Submission Acknowledgment

RE: DA2019/1173 - 3 Berith Street WHEELER HEIGHTS NSW 2097

RE: DA2019/1173 - 3 Berith Street Wheeler Heights NSW 2097

See Drawing no. A08 WEST ELEVATION on 'Plans - External updated with additional plan - 11/11/2019' (also below)

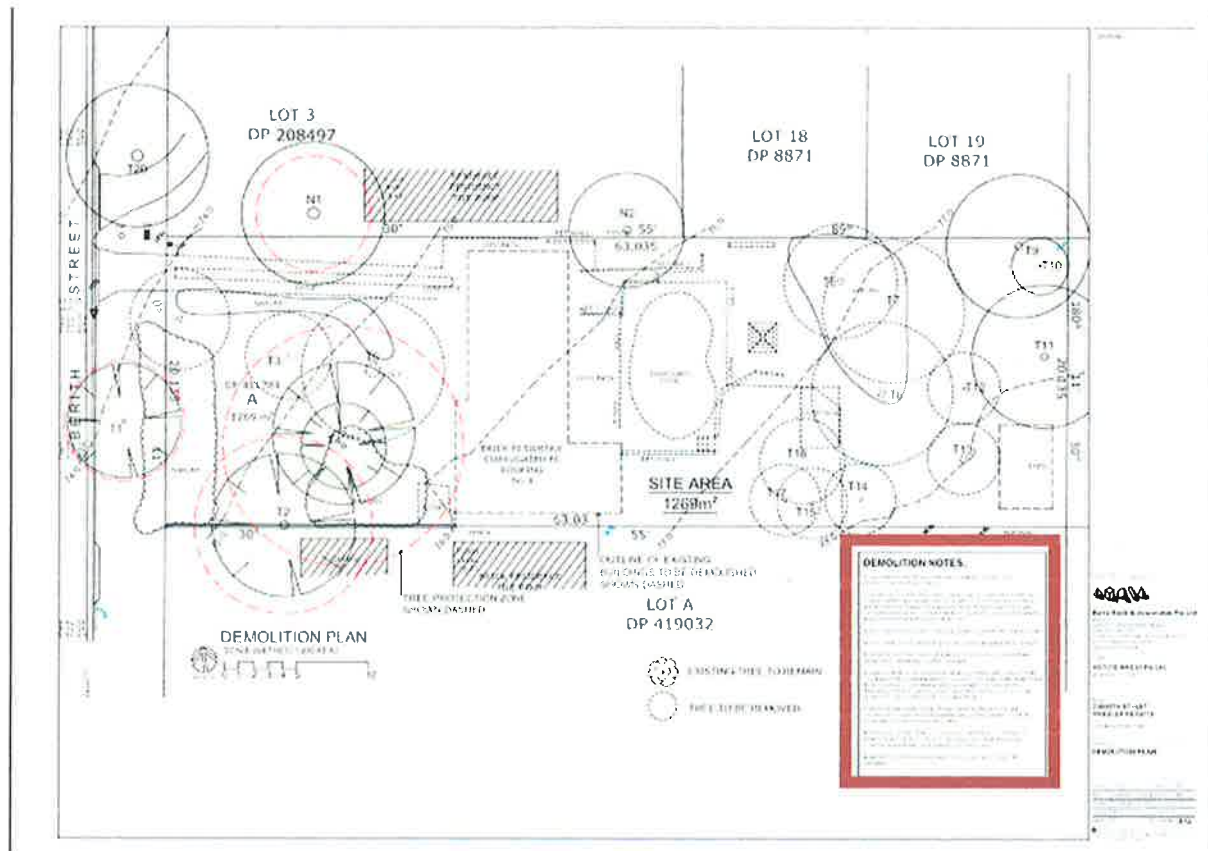
- 3.1 The plan must be reduced from 6 dwellings to a maximum of 4 dwellings that include at least one single story.
- 3.2 The single story dwelling/s must be at the front of the block, set back on the same line as neighbours' houses.
- 3.3 The maximum height of any single storey dwellings, including the HIGHLIGHT WINDOWS and anything else on the roof, is to be no higher than the existing house's pitched roof at 3 Berith St, to ensure no loss of sun and existing district views to Sydney Bahá'í Temple for 5 Berith St.
- 3.4 Parking must be provided on the same level as dwellings and not underneath - ie not in a ~4.7 m deep excavation. e.g.

- As there are not 'to scale' drawings of the proposed buildings in relation to neighbours' buildings, I would request that there be **installation of height poles** on the development site to demonstrate the height and envelope of the works, **including to the top of the HIGHLIGHT WINDOWS as these are well above the roof height, and take into account any lift, water or other items that will be above the roof.**
- The height poles must be checked and certified by a Registered Surveyor as being accurate with relevant certification submitted to Council.
